Proposed Revisions to a Standard Plans Index

Index Number: 521-510

Index Title: CONCRETE BARRIER/NOISE WALL (8'-0")

ELEVATION

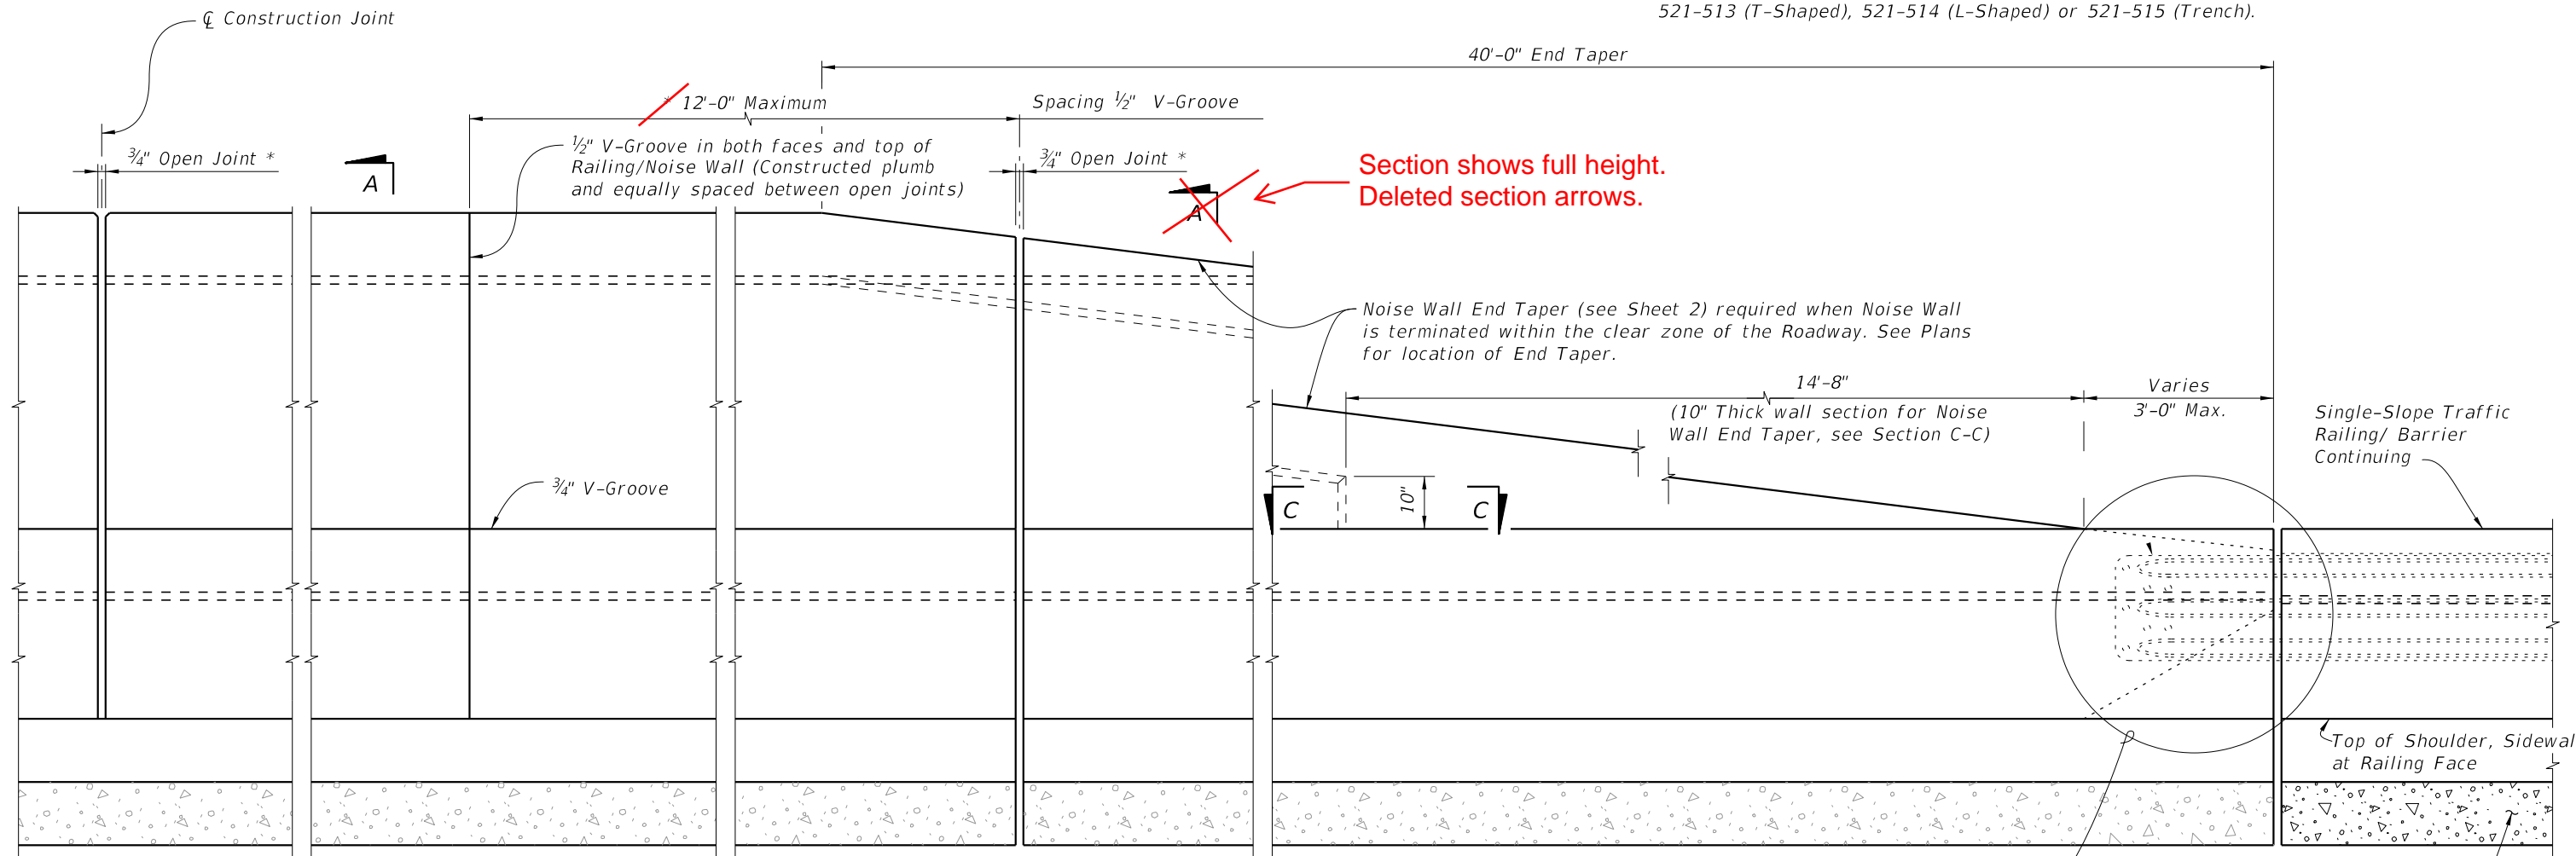
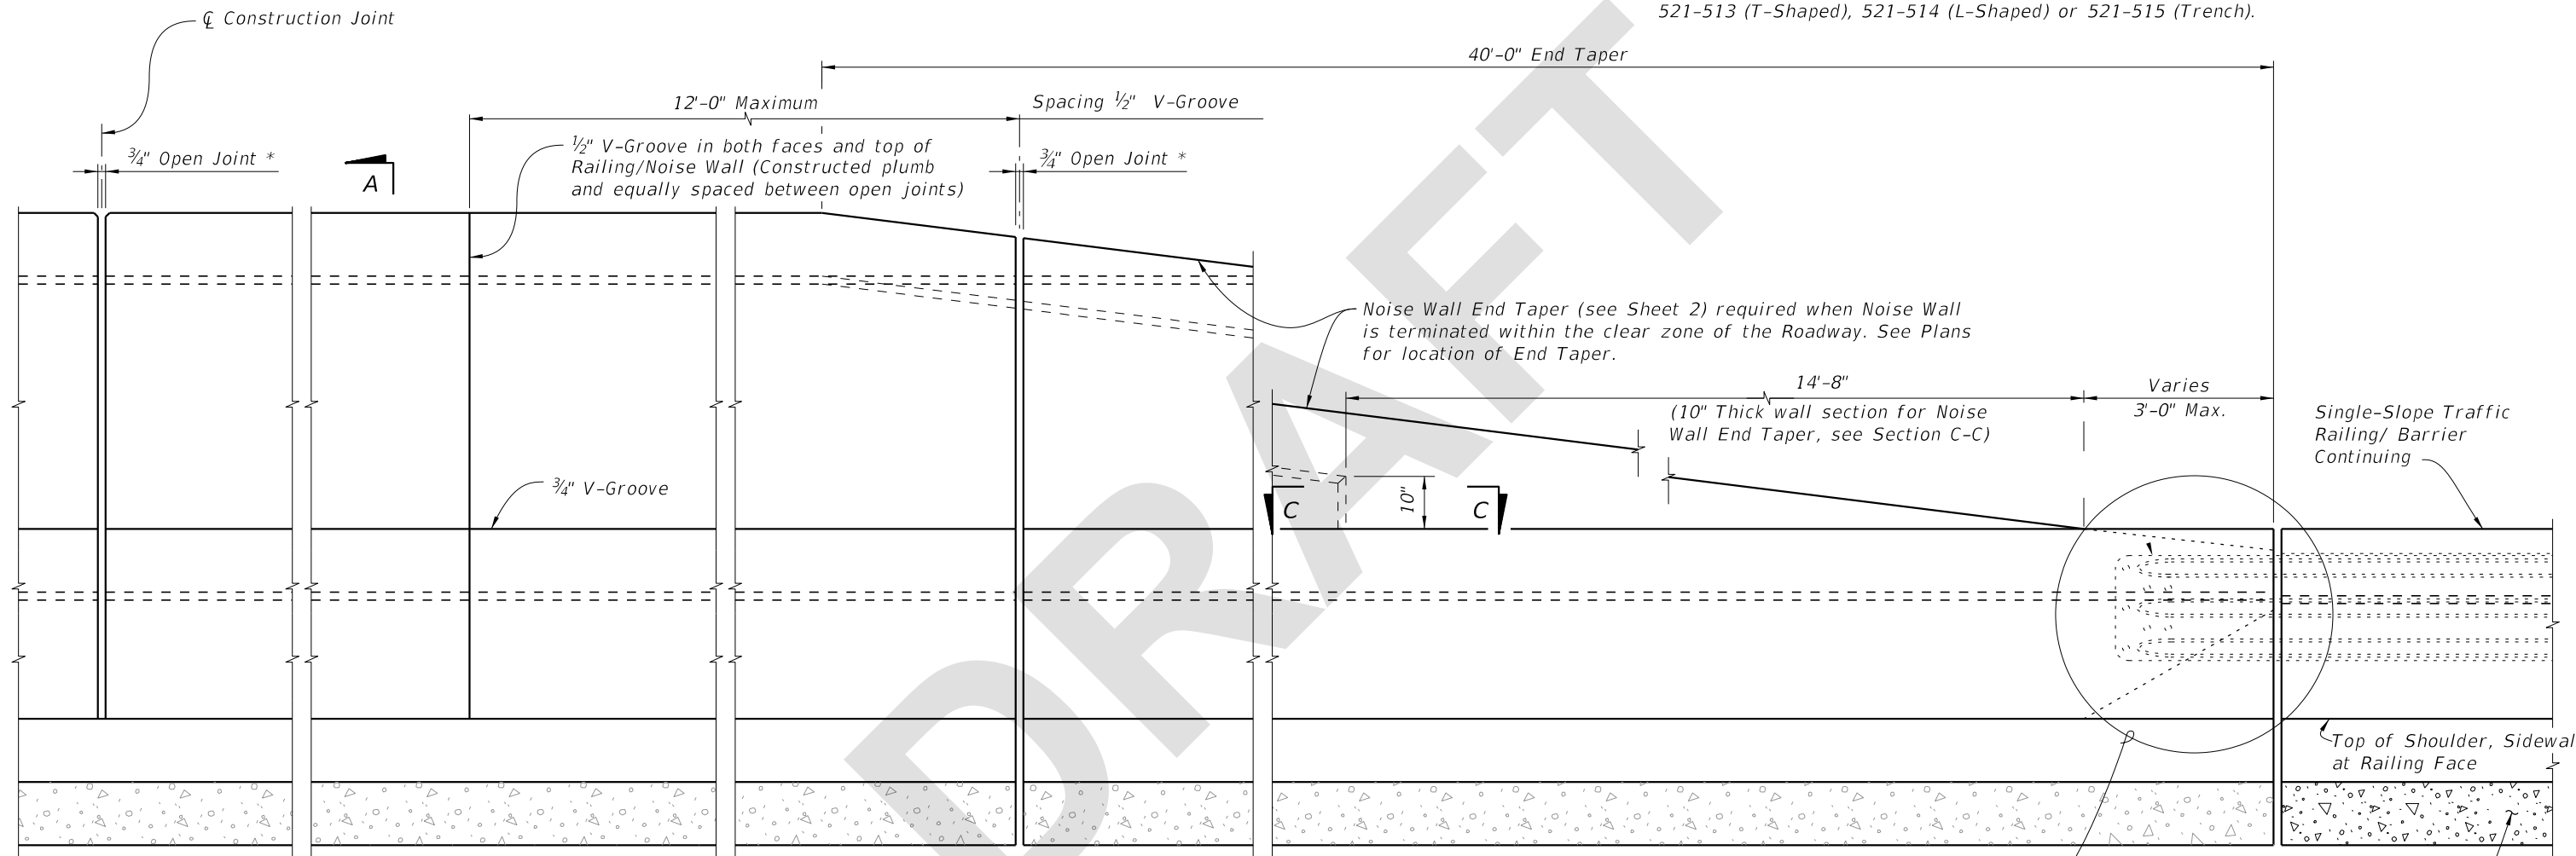
Sheet 1: Deleted section cut lines A-A.

Section shows full height.
Deleted section arrows.

REINFORCING STEEL BENDING DIAGRAMS

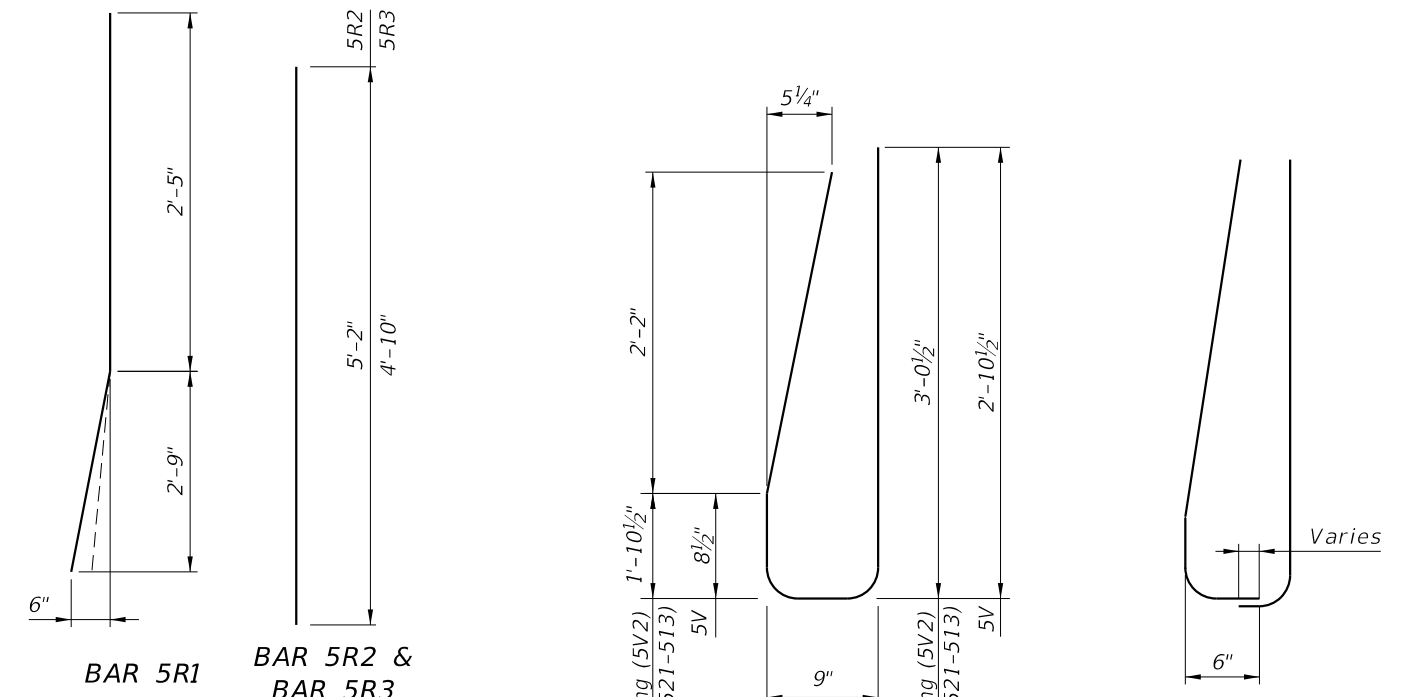
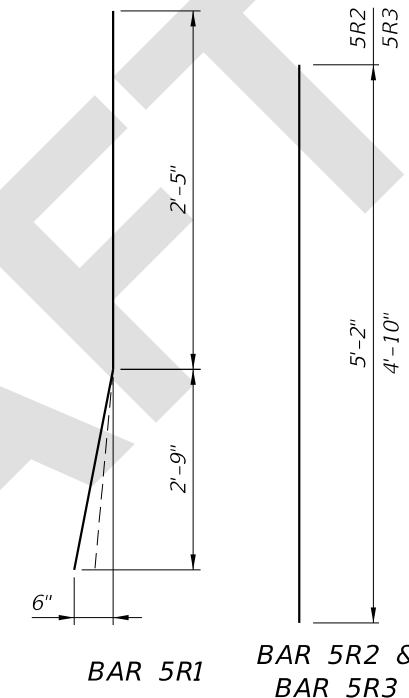
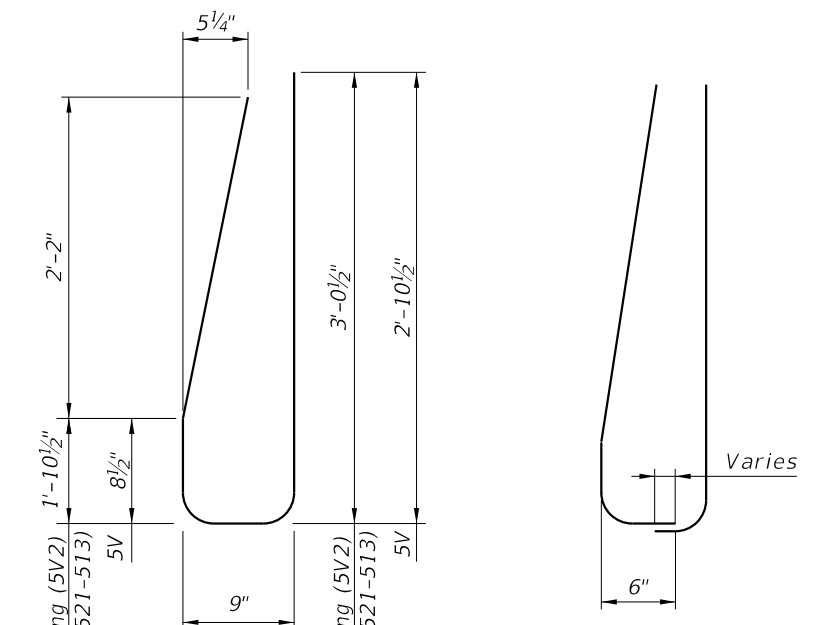
Sheet 4: Corrected reinforcing steel estimated quantities.

The estimate for reinforcing steel was slightly off for the CIP version. We updated the estimate.

CHANGED TO:
81.55
241.58

ESTIMATED TRAFFIC RAILING/NOISE WALL QUANTITIES		
ITEM	UNIT	QUANTITY
Concrete (Railing)	CY/LF	0.107
Concrete (Noise Wall)	CY/LF	0.136
Reinforcing Steel (Typical)	LB/LF	81.55
Additional Reinf. @ Open Joint	LB	241.58
